Our ref: 5676

Information request response (pursuant to Schedule 2, Part 2, Section 1 (6) of the Abbot Point SDA Development Scheme (November 2014))

Your Ref: AP2025/009

We refer to the information request, dated 14 October 2025, for the SDA application for material change of use for a utility installation (water pipeline and pump station) in the Abbot Point State Development Area (SDA).

SALISBURY FACILITY SITE
TOTAL AREA: 2 Ha
ACCESS TRACK AREA: TBC
TOTAL LENGTH OF SECURITY FENCE: 600m
PUMP STATION FOOTPRINT: 685m²

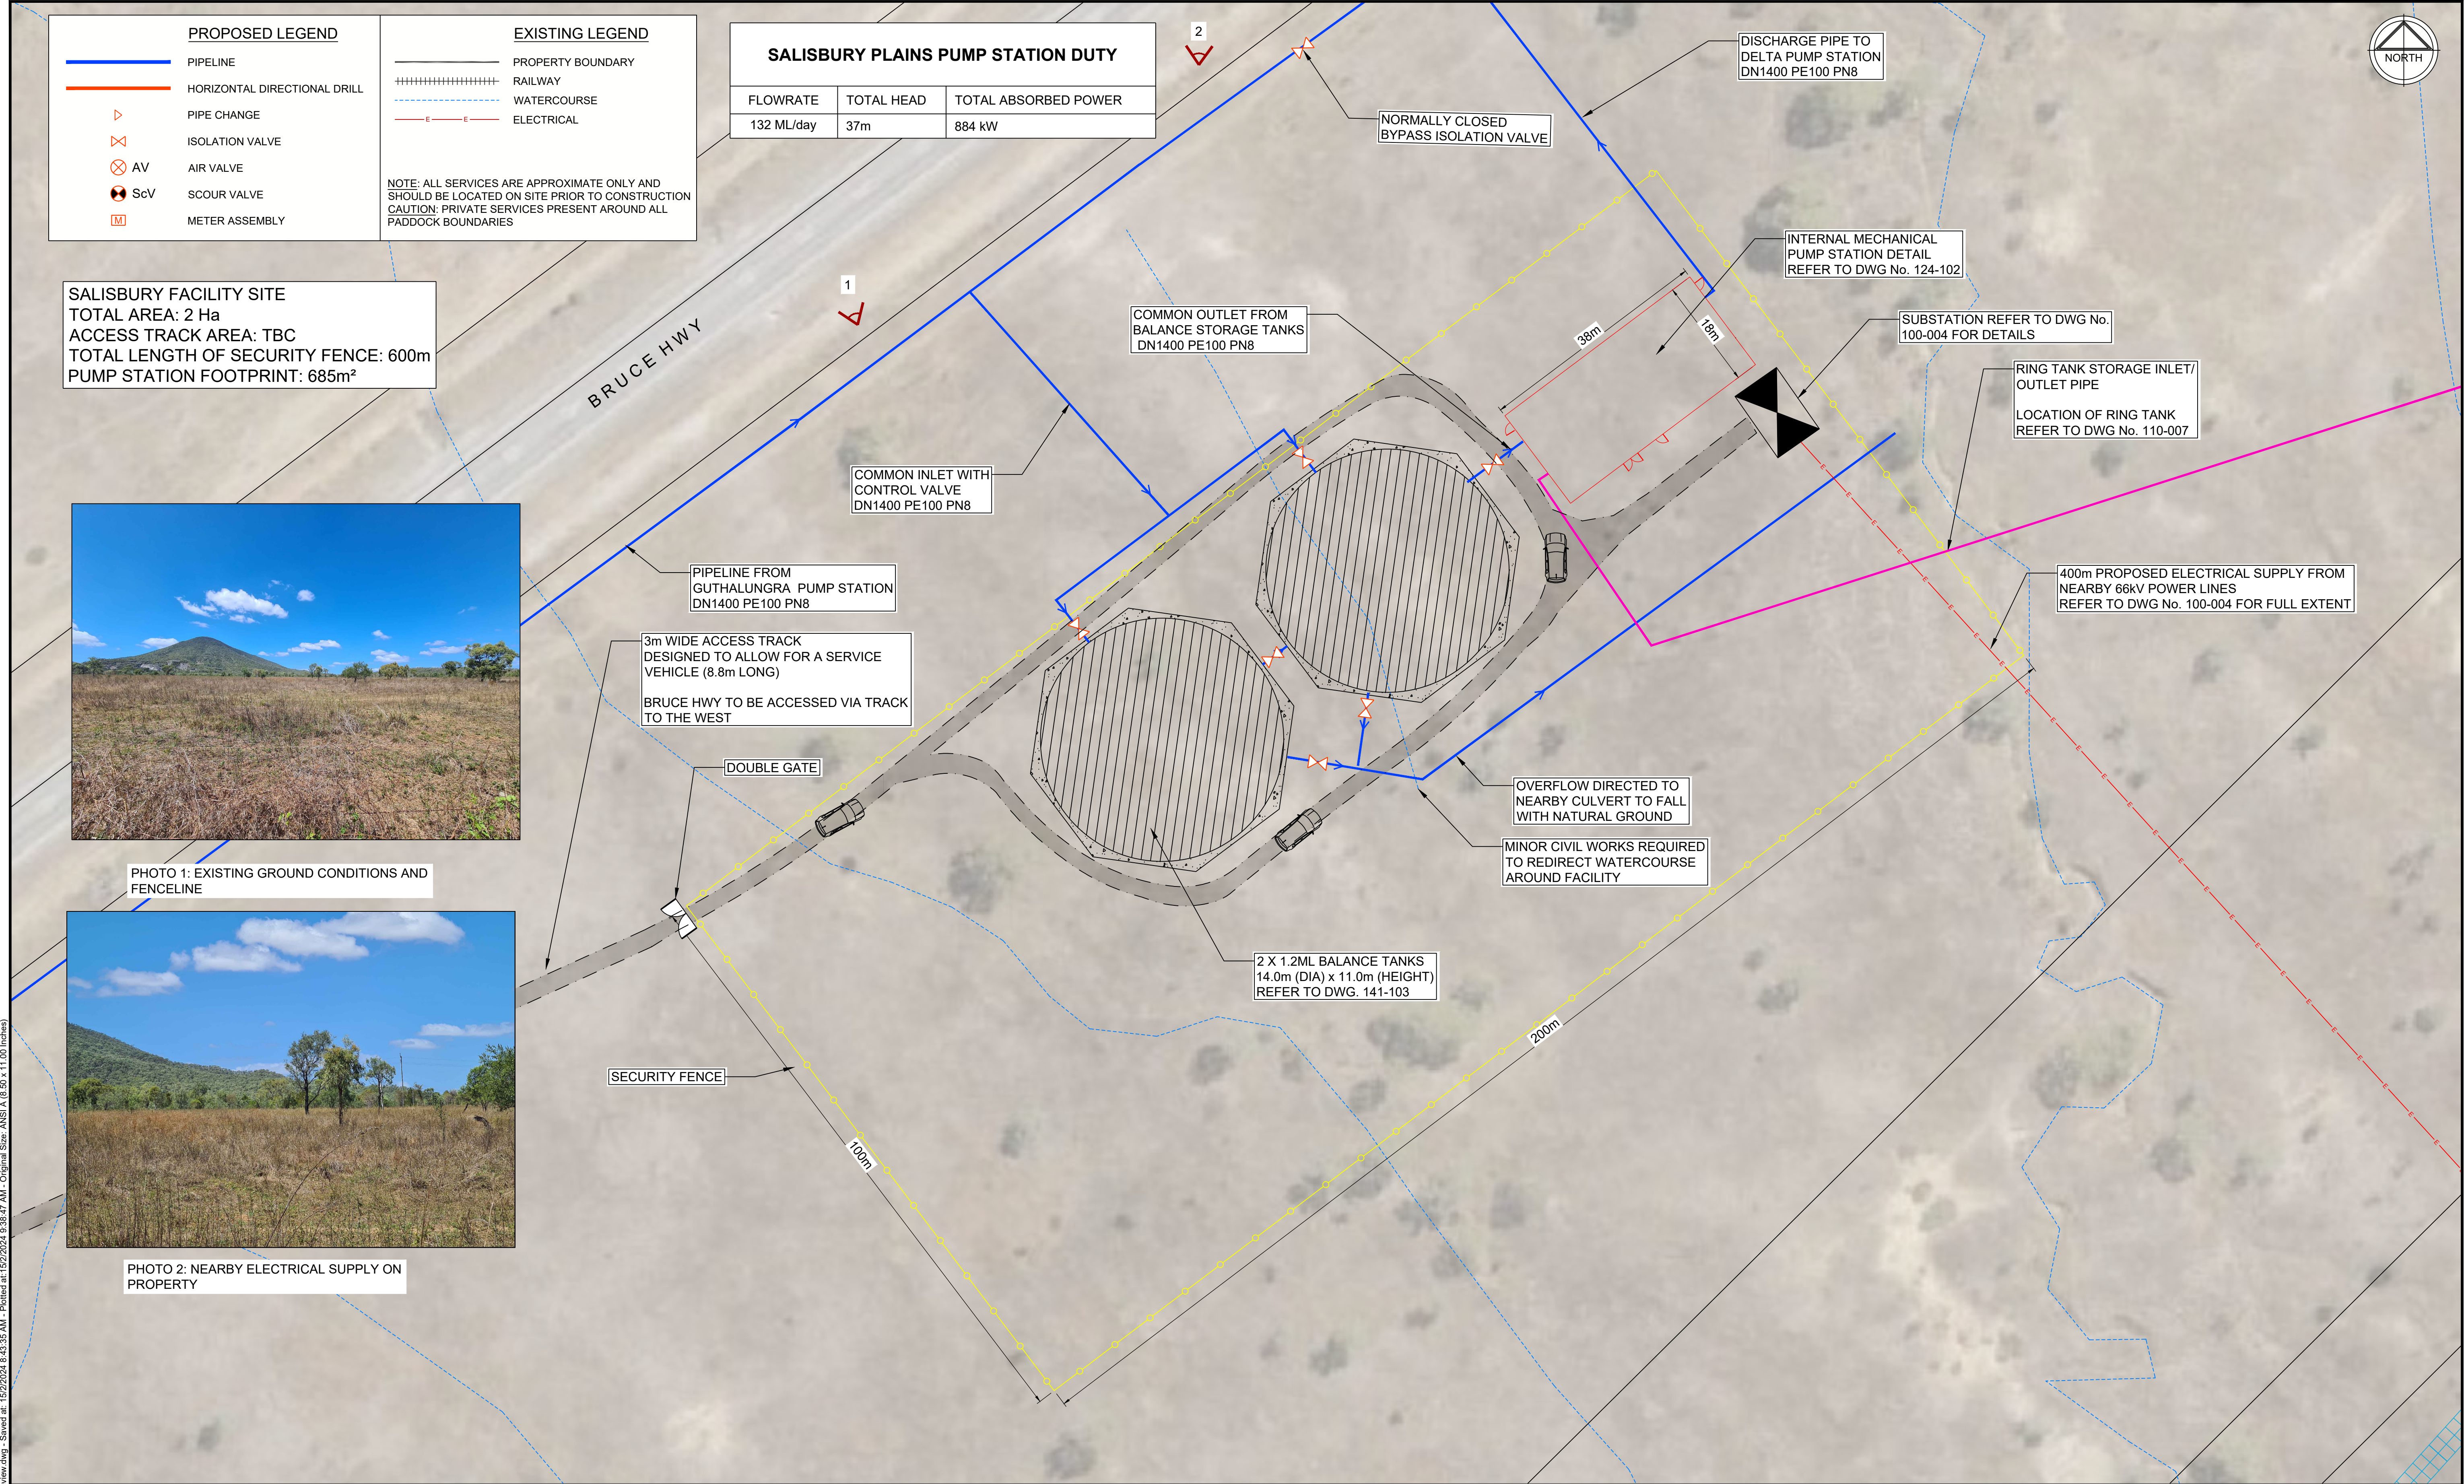
1. Provide a separate site layout plan of the Salisbury Plains Pump Station & Balance tank location referred to in Figure 3 of the Planning Report and a separate plan showing the proposed height and visual appearance referred to in Figure 4 of the Planning Report.
2. Provide plans clearly showing the proposed location of electrical transmission infrastructure within the SDA.

Attachment B contains preliminary plans which show the indicative layout of the proposed pump station, including proposed electrical connection. The ultimate layout and built form would be subject to detailed design. It is expected that subject to detailed design, key details of the pump station would be as follows:

- Access: Operational access via a 3-5m wide access track extending from an access point off the Bruce Highway approximately 900m to the west.
- Fenced compound: Approximately 20,000m² to 30,000m².
- Balance tanks:
 - Quantity: 2 x tanks
 - Volume: 1.2-1.5ML each
 - Height: 11-14m
- Pump station building:
- Height: 1-2 storeys
- GFA / internal floor area:
- Substation: 11-11kV (2MVA)
- Electrical supply: approximately 400m 66Kv feeder line to existing 66kV Merinda-Home Hill overhead powerline.
